Project	<b>IEEE 802.16 Broadband Wireless Access Working Group</b> < <a href="http://ieee802.org/16">http://ieee802.org/16</a> >	
Title	<b>Comments on AWD Uplink Physical Structure</b>	
Date Submitted	<b>2009-07-06</b>	
Source(s)	Yih-Guang Jan, Yang-Han Lee, Hsien-Wei Tseng, Ming-Hsueh Chuang, Jheng-Yao Lin <b>Tamkang University (TKU)</b>	yihjan@yahoo.com
	Youn-Tai Lee, Chun-Yen Hsu <b>Institute for Information Industry (III)</b>	lyt@nmi.iii.org.tw
	Shiann-Tsong Sheu <b>National Central University (NCU)</b>	stsheu@ce.ncu.edu.tw
	Whai-En Chen <b>National Ilan University (NIU)</b>	wechen@niu.edu.tw
Re:	802.16m amendment working document  "Comments on AWD 15.3.8 Uplink Physical Structure"	
Abstract	Comments on AWD Uplink Physical Structure	
Purpose	To be discussed and adopted by TGM for the 802.16m AWD.	
Notice	<i>This document does not represent the agreed views of the IEEE 802.16 Working Group or any of its subgroups. It represents only the views of the participants listed in the "Source(s)" field above. It is offered as a basis for discussion. It is not binding on the contributor(s), who reserve(s) the right to add, amend or withdraw material contained herein.</i>

## Comments on A

Figure 497—Pilot patterns for contiguous LRUs for 3 Tx streams

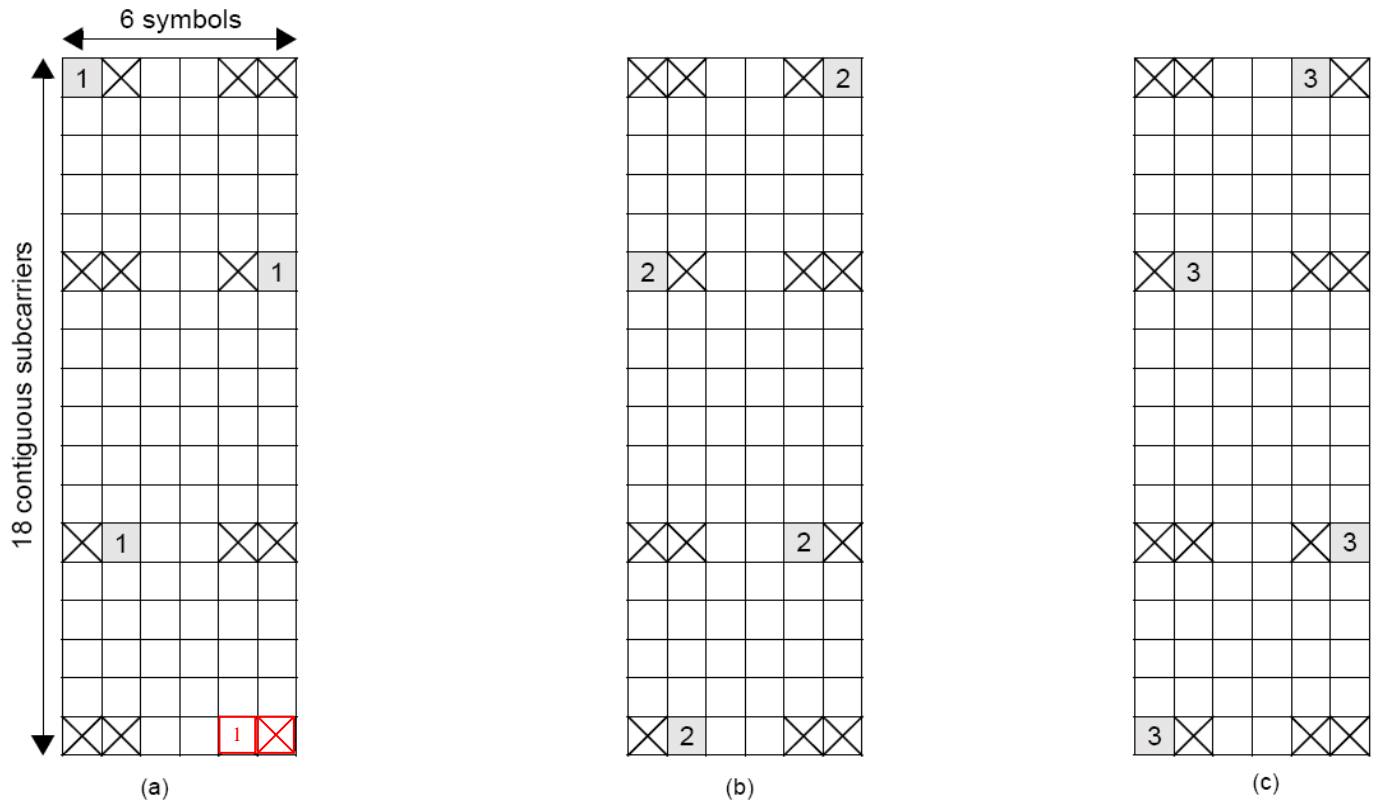
This contribution provides the corrected AWD text proposal to Pilot Patterns. In Figure 497, it has an error and needs correction.

*[In IEEE 80216m-08\_0010r2, Section 15.3.8.4, replace the original Figure 497 by the following corrected figure.]*
